# TECHNICAL BULLETIN

## K413NAS1

Service Action: Towbar Under Torqued

#### **F-PACE (X761)**

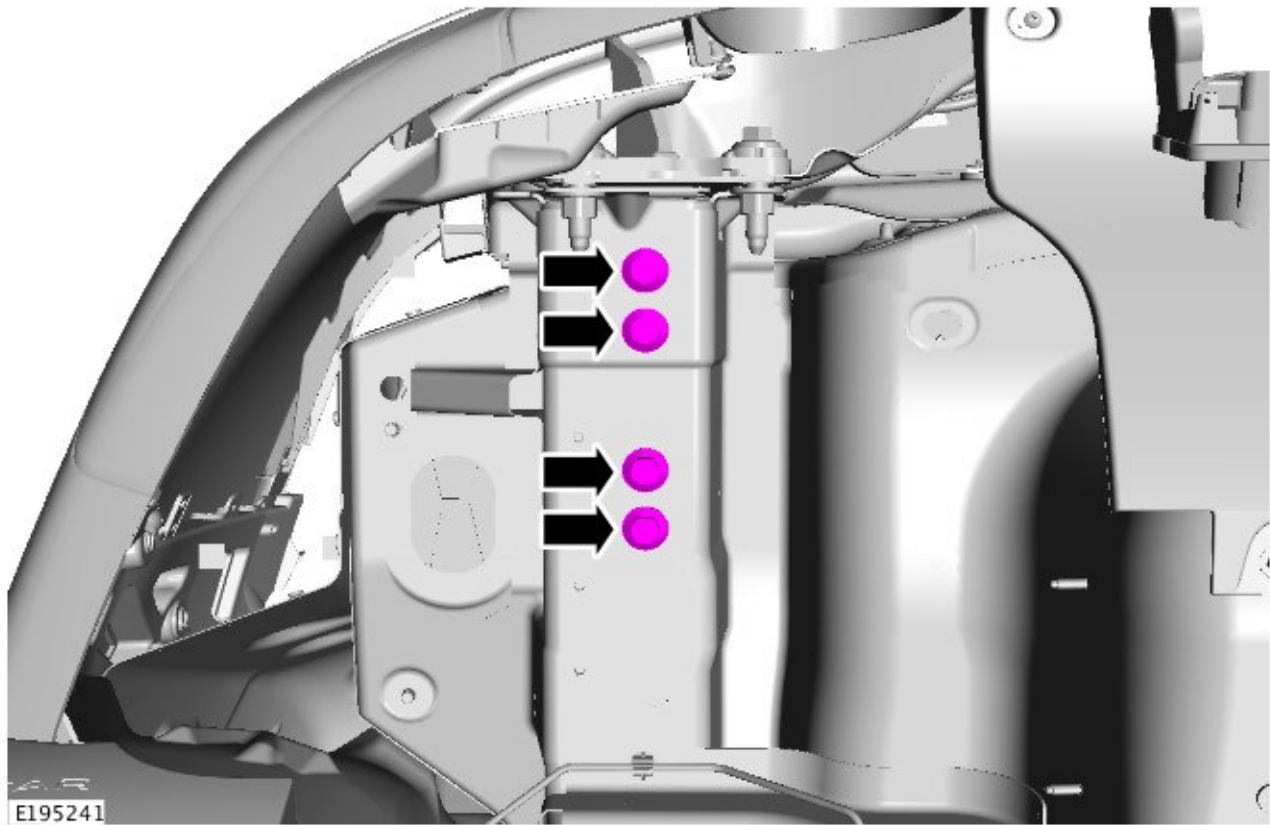
5.  **NOTE: Left-side shown; right-side similar.**

**NOTE: Torque: 100Nm +240 deg [ $\pm$  2 deg]**

Visually check the four towbar bolts for damage.

- If any of the four towbar bolts are damaged, install four new towbar bolts.
- If the towbar bolts are not damaged, install the original towbar bolts.
